Basic Shirt Ltd. (9909)

Basic Tower, Harvaid, Mazu Khan, Pashim para, mosjid, Gazipur sadar, Gazipur.

24.06.2014

Identified Priority 1 Concerns

2nd Priority 2 Concern

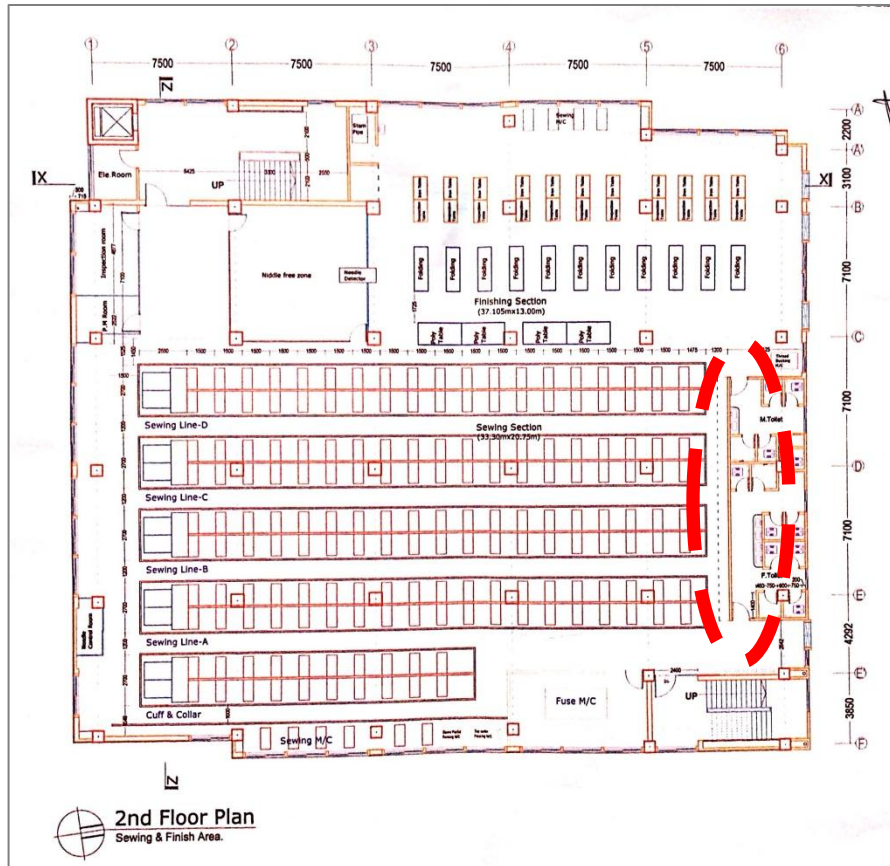
The Toilet block of the Factory building is has 5" thick brick partition walls that are not over the beams.

The toilet has a floor finish of about 16" which could apply a local dead load of approximately 10 kN/m². Moreover the toilets partially sit on a cantilever slab. These loads in addition to live load of 2kN/m² could overstress the structure.

Item No.	Observation	Recommended Action Plan	Recommended Timeline
1	Priority 2 - Factory Buildings Loading plan has to be revised.	Carry out an Engineering Assessment to verify all the actual load bearing capacity for the slabs, beams and the columns.	6-weeks
2	Priority 2 - Factory Buildings Loading plan has to be revised.	Develop and maintain a proper loading plan.	6-months
3	Priority 2 - Factory Building toilet block contains brick partition walls that are not over the beams and the toilets have increased floor finish.	Carry out a Detailed Engineering Assessment to verify all the structural system of the partition walls and the increased floor finishes. No loads such as fabric or equipment should be placed in the area 3 meters around the toilets until the DEA is completed.	6-weeks
4	Priority 2 - Factory Building toilet block contains brick partition walls that are not over the beams and the toilets have increased floor finish.	Carry out any strengthening works recommended in the DEA.	6-months

1st Priority 3 Concern

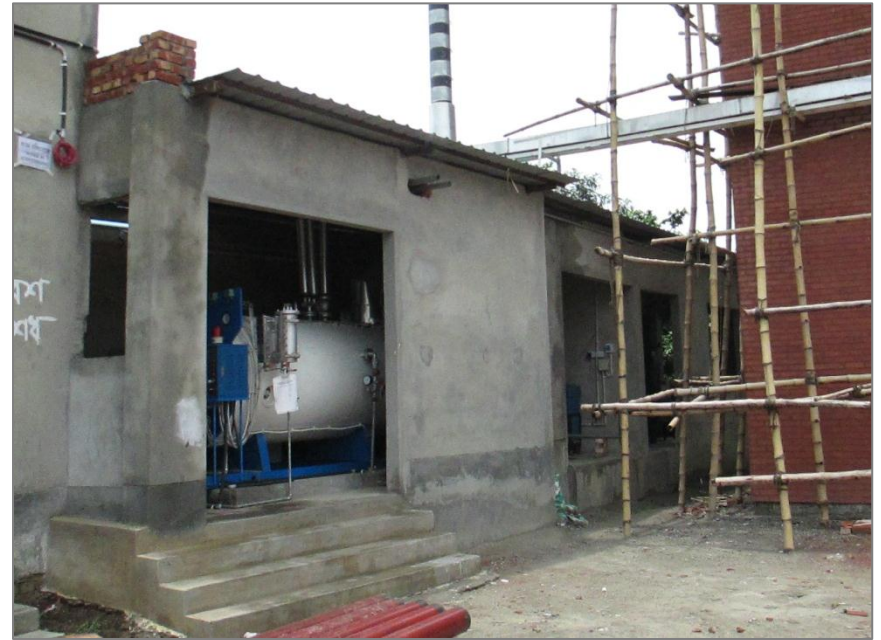
The opening of the lift core is not properly secured in all the floors. Any unsuspecting worker could tip over the unsecured closures and fall down.

5	Priority 3 - Factory Building - Guard rail at the elevator shaft is not secure.	Secure the openings with a guard rail or wall meeting BNBC requirements. Close them down properly until the lift is installed. Put caution signs in front of the openings.	6-weeks
6	Priority 3 - Generator, Sub-station, Compressor and Boiler Sheds Structural steel roof has to be checked.	Carry out an Engineering Assessment to verify all the structural system of these sheds. Develop proper structural steel documents. The factory engineer must check the steel roofs against uplift wind pressure.	6-weeks
7	Priority 3 - Generator, Sub-station, Compressor and Boiler Sheds Structural steel roof has to be checked.	Carry out any repair works if necessary suggested by the factory engineer.	6-months
